Application No.	Applicant(s)	
	10/043,653	ROBERTSON, JAMES	§ F.
Office Action Summary	Examiner	Art Unit	
	Tony G Soohoo	1723	
The MAILING DATE of this communication app Period for Reply	pears on the cover sheet	with the correspondence addres	SS
A SHORTENED STATUTORY PERIOD FOR REPL THE MAILING DATE OF THIS COMMUNICATION. - Extensions of time may be available under the provisions of 37 CFR 1.1 after SIX (6) MONTHS from the mailing date of this communication. - If the period for reply specified above is less than thirty (30) days, a repl If NO period for reply is specified above, the maximum statutory period Failure to reply within the set or extended period for reply will, by statute Any reply received by the Office later than three months after the mailin earned patent term adjustment. See 37 CFR 1.704(b).	I36(a). In no event, however, many within the statutory minimum of will apply and will expire SIX (6) Note, cause the application to become	r a reply be timely filed thirty (30) days will be considered timely. IONTHS from the mailing date of this commu	nication.

DETAILED ACTION

Claim Rejections - 35 USC § 103

MARK UP OF MOORE PATENT (fig 1) and Application drawing (fig 2)

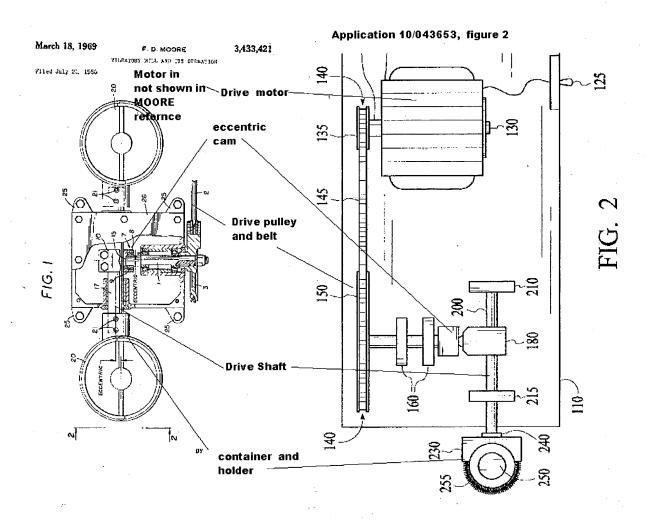
The reference to Miller teaches that a driven shaking device may be provided with a motor and motor shaft 46a and motor shaft pulley 48 a connecting belt 50 in connection to a rotating shaft pulley 52 to provide an appropriate drive forces from the motor shaft to the rotation shaft 42, see figure 5, via the eccentric thereby providing a rotation and reciprocational component to the mixing vessel, see mark up of MOORE.

With regards to the rotation, it is noted that all of the structural elements of the Moore Patent has been found as a finding of fact to a corresponding structure of the applicant's disclosed apparatus (see MARK UP OF MOORE PATENT), accordingly, it is deemed that the operation of Moore's device would produce the recited rotation and
